RE: Marsh Landing Generating Station
Application for Certification 08-AFC-03

Responses to Data Request Set 2: (#60–63)

Application for Certification (08-AFC-03) for MARSH LANDING GENERATING STATION Contra Costa County, California

Technical Area: Biological Resources
Author: Heather Blair

FIGURE 63-1b

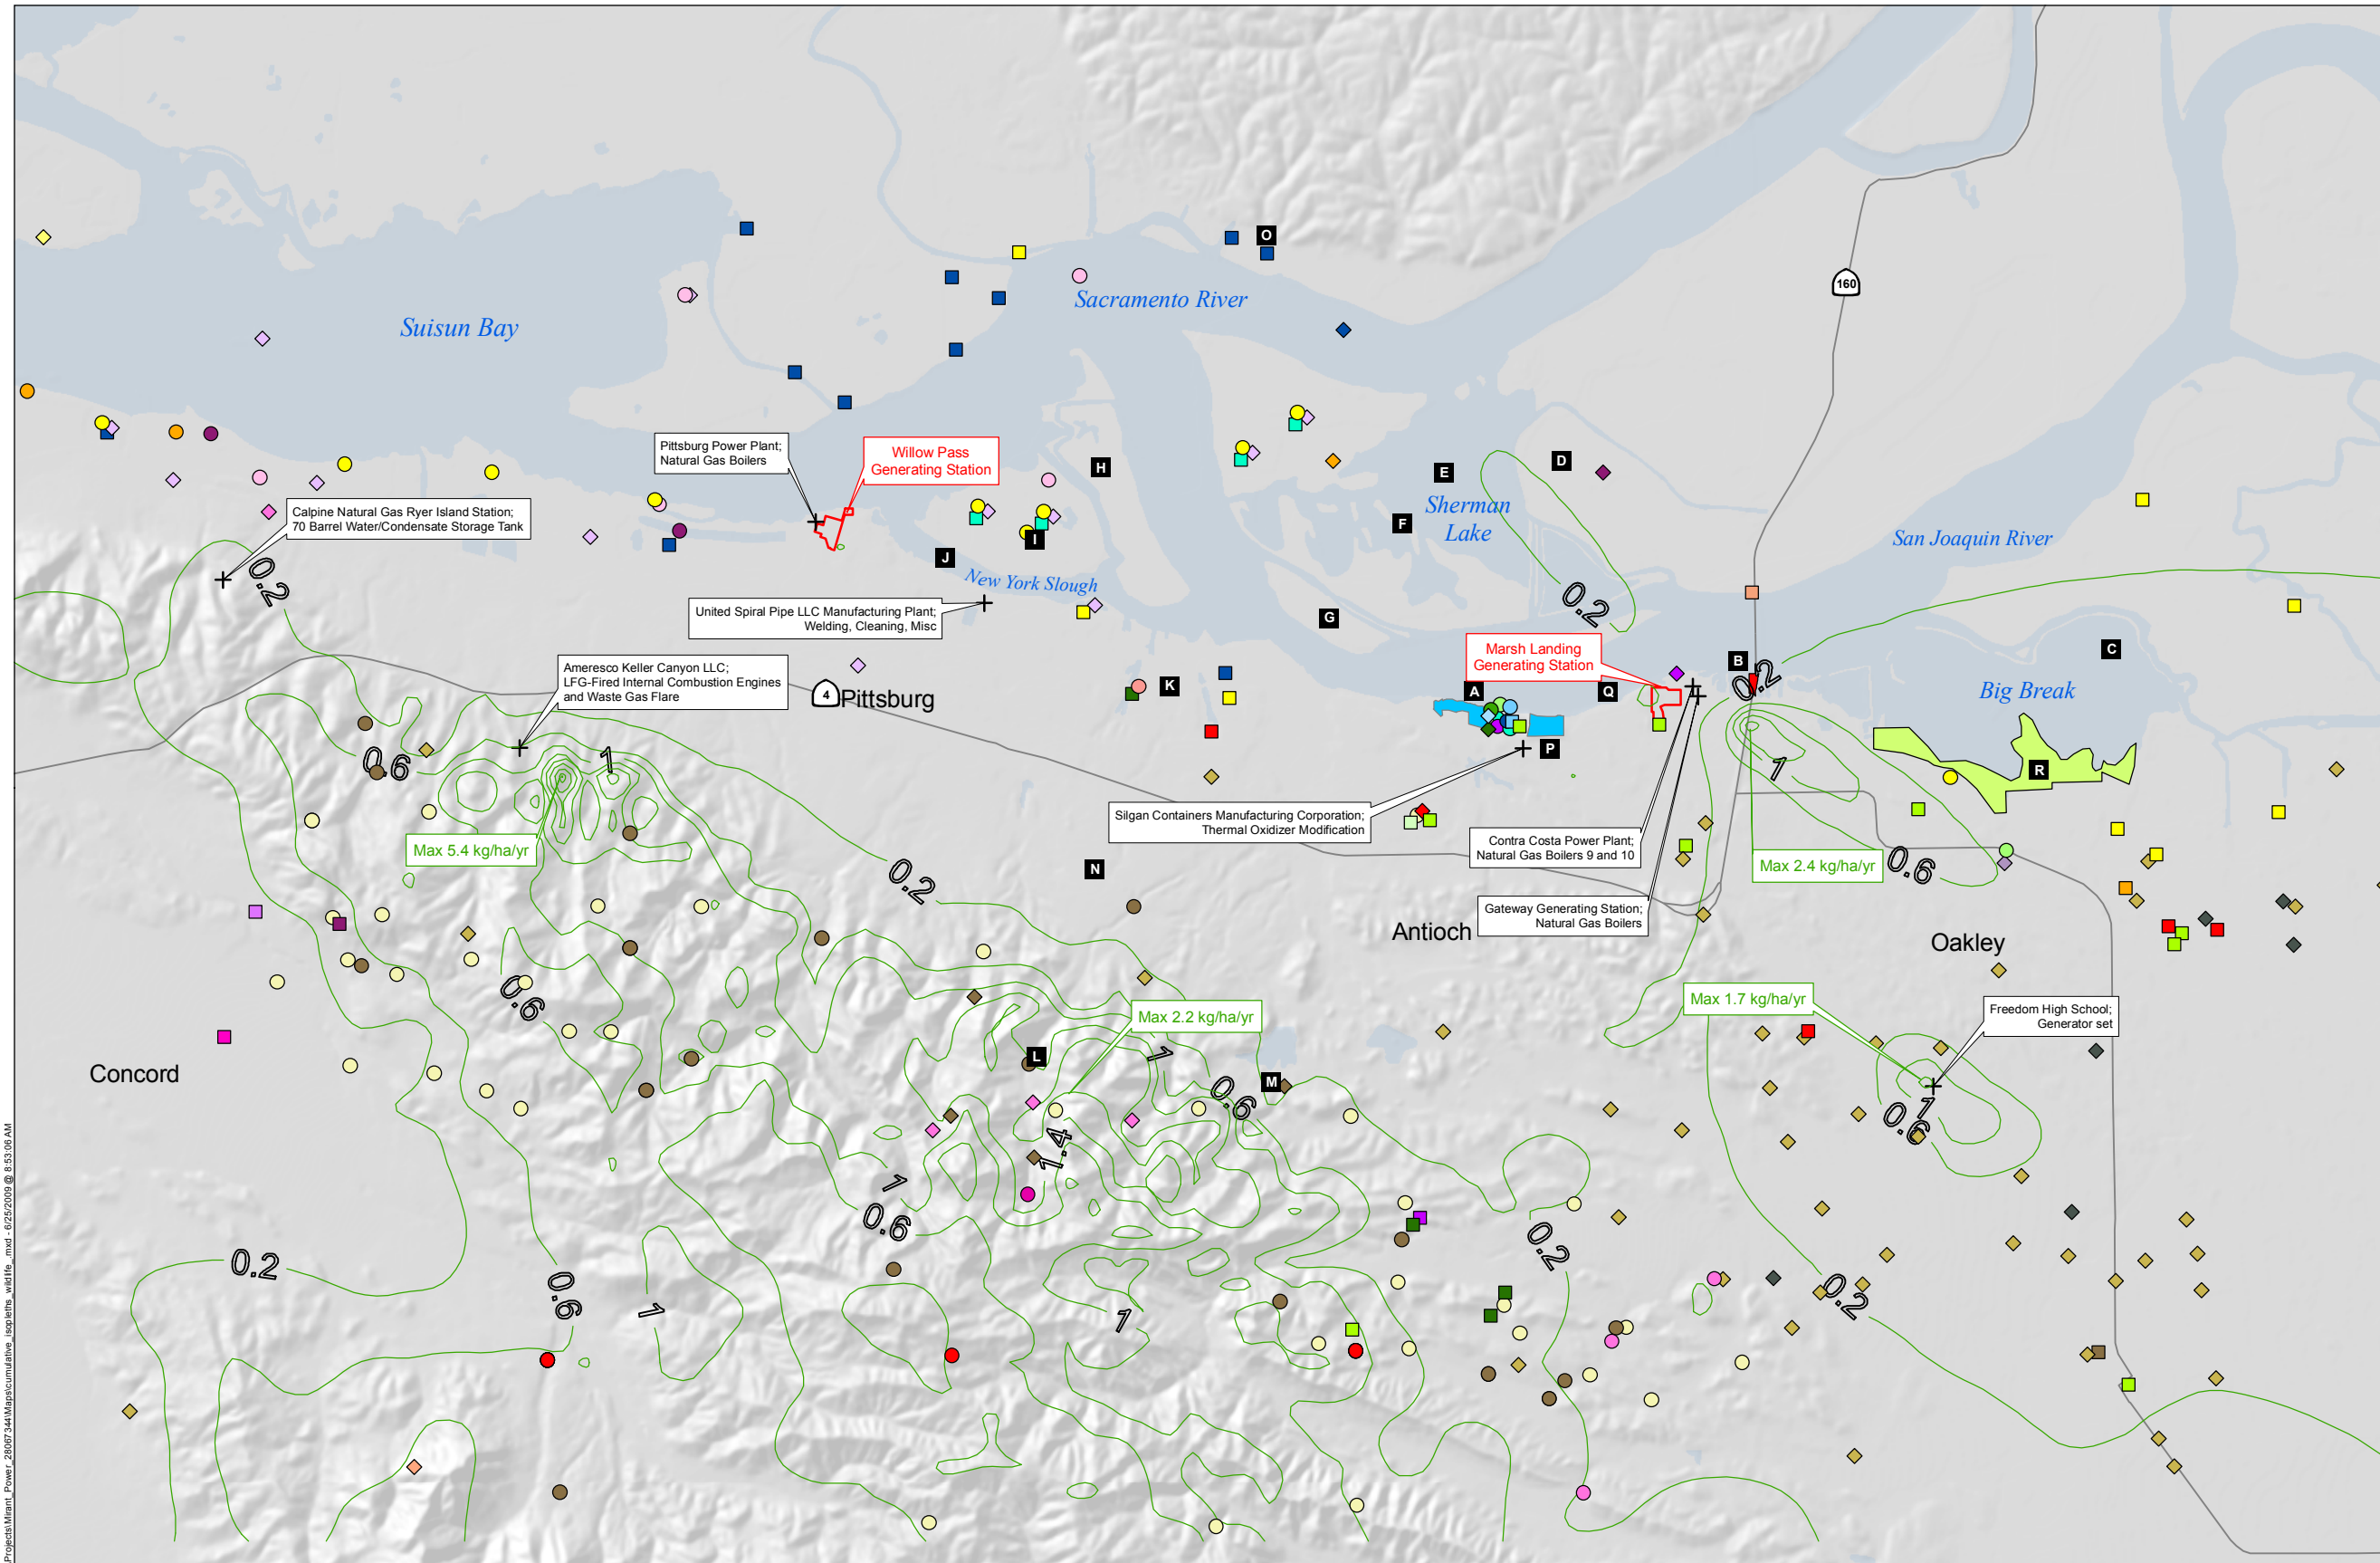
- 63. Please update the cumulative impact analysis (Tables 9-1 and 9-2) in Responses to Data Request Set #1 (Data Request #9) with nitrogen deposition values in kg/ha/yr. Provide an isopleth graphic over USGS 7.5-minute maps (or equally detailed map) of the direct nitrogen deposition values in the cumulative analysis.**

Figures 63-1a and 63-1b provide the isopleths for nitrogen deposition rates in kg/ha/yr due to all cumulative sources listed in Table 63-1. Figure 63-1a shows the federal and state listed special-status vegetation species. Figure 63-1b shows the federal and state listed special-status wildlife species.

As seen in Figures 63-1a and 63-1b, the maximum cumulative nitrogen deposition value occurs in the hills south of Pittsburg, which is located more than 9 miles southwest of the MLGS project site. The maximum nitrogen deposition rate for all cumulative sources is estimated to be 5.4 kg/ha/yr (without background) near the Ameresco Keller Canyon facility. This is the only area that would exceed the benchmark of 5 kg/ha/yr with background; however this area is not considered sensitive to nitrogen deposition since sands or serpentine soils are not known to be present. Approximately 98 percent of the highest nitrogen deposition rates in these hills are caused by nitrous oxide emissions from sources at the Ameresco Keller Canyon LLC facility, which includes two landfill gas-fired internal combustion engines and a waste gas flare.

Other localized nitrogen deposition areas include the region around the Freedom High School generator set and the area to the southeast of the MLGS site (near Areas R and B on the figures). The maximum value near the Freedom High School generator set is 1.7 kg/ha/yr without background and the maximum value southeast of MLGS near Highway 160 is 2.4 kg/ha/yr without background. Nitrogen deposition values in these areas to the southeast of
